RFI

To: Jordan & Skala Engineers, Inc. RFI #: 37  
 14240 Midway Road, Suite 350 Date: 1/23/2012  
 Dallas, TX 75244 Job: EB-02 Keller Springs Lofts  
 Ph: 469/385-1616 Fax: 469/385-1615 Phone: 877-777-5115

CC:  
 Subject: 6" main sanitary trunk line  
 Drawing: P-3.0C P-3.0E Spec Section:  
 Cost Impact: None Schedule Impact: None

CC: David Gallagher (Embrey Build (Embrey Construction LLC))  
 Subject: Pool and fountain equipment drain requirements  
 Drawing: landscape 5C Spec Section:  
 Cost Impact: None Schedule Impact: None

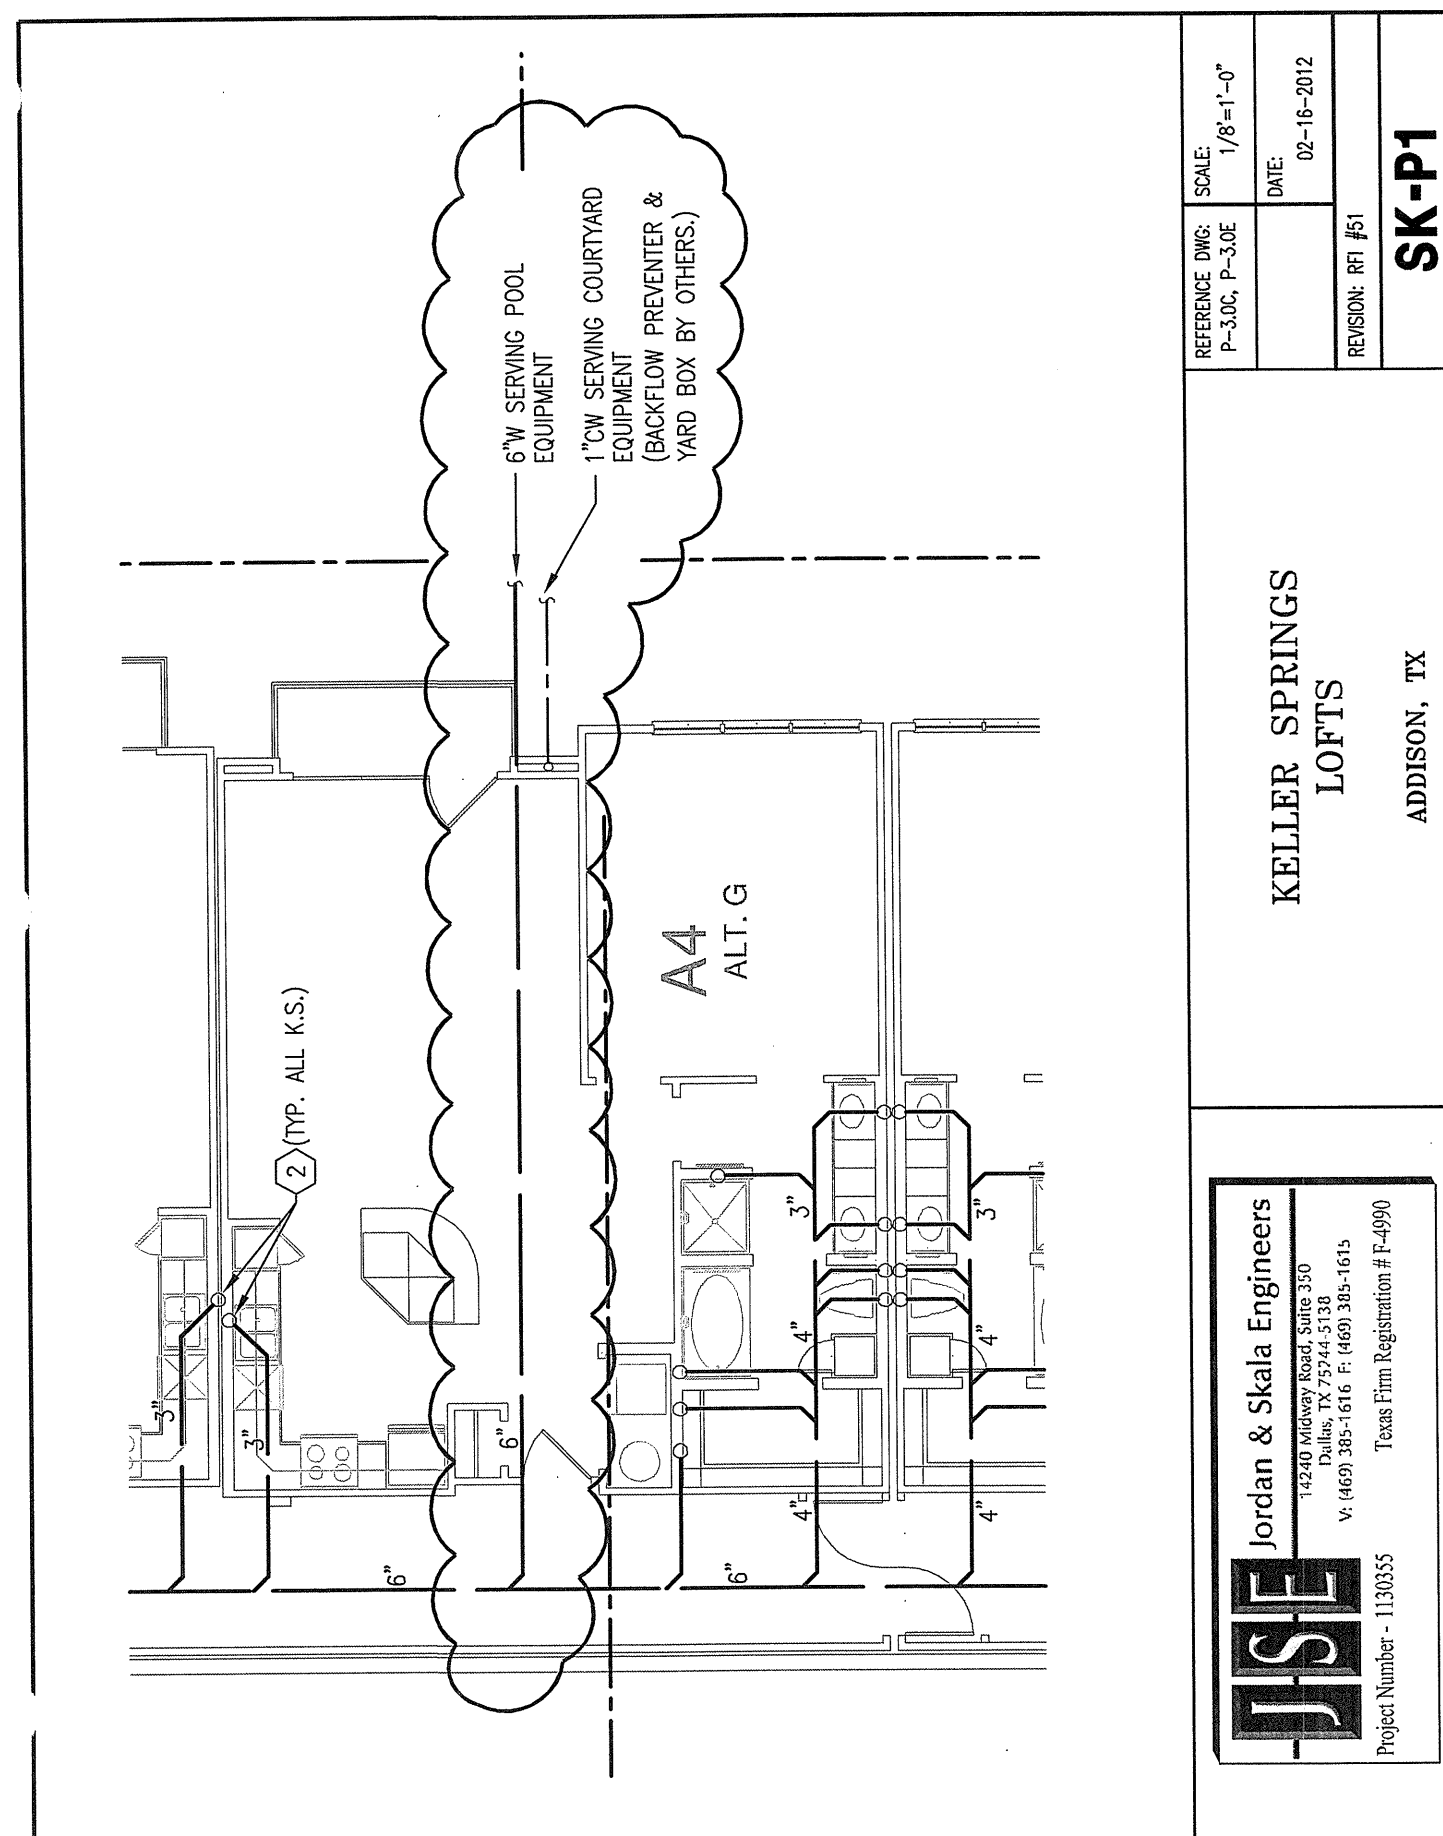
**Request:** Date Required: 2/14/2012  
 Jordan and Skala,  
 In discussing the courtyards fountain and pool equipment requirements with our pool contractor, it has come to our attention that since the pool equipment will have a chlorinated filter system, by code, we are required to run that into the sanitary sewer. The fact that the fountain equipment is run with a non-chlorinated system, the pool contractor believes that the fountain equipment can be run into the existing storm sewer system in the fountain courtyard. Therefore we need Jordan and Skala to revise the plans accordingly.  
 Please reference landscape sheet 5C of 9 for pool equipment location.

**Response:**  
 A 6" sanitary waste line has been routed to pool equipment area for pool drainage. See attached sketch.
